## SUNDRY NOTICES AND REPORTS ON WELLS

M.K. Stewart #3

30-025-22489

Permanent Abandonment of Federal Wells  
Conditions of Approval

OXY USA Inc. - Proposed  
M.K. Stewart #3  
API No.30-025-22489

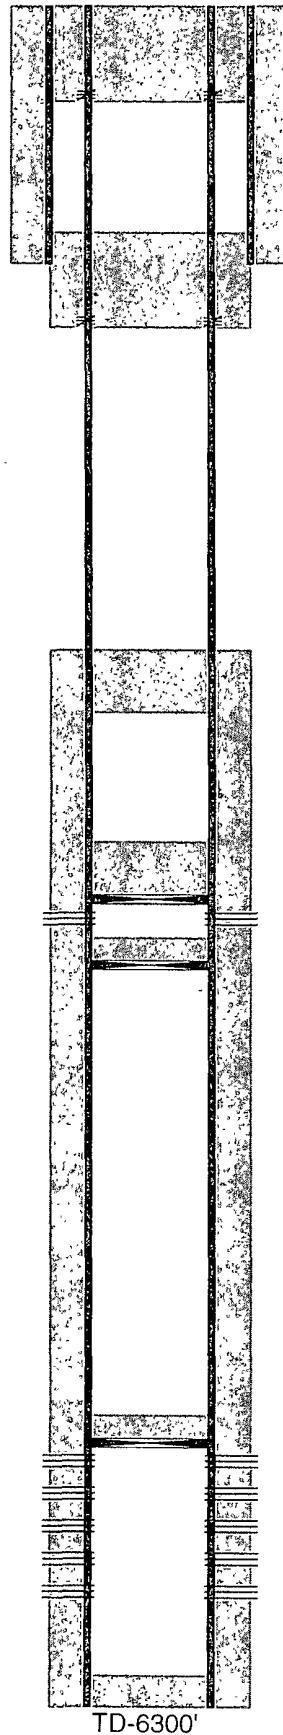
RECLAMATION PROCEDURE  
ATTACHEDSEE ATTACHED FOR  
CONDITIONS OF APPROVAL

Ground Level Dry Hole Monitor
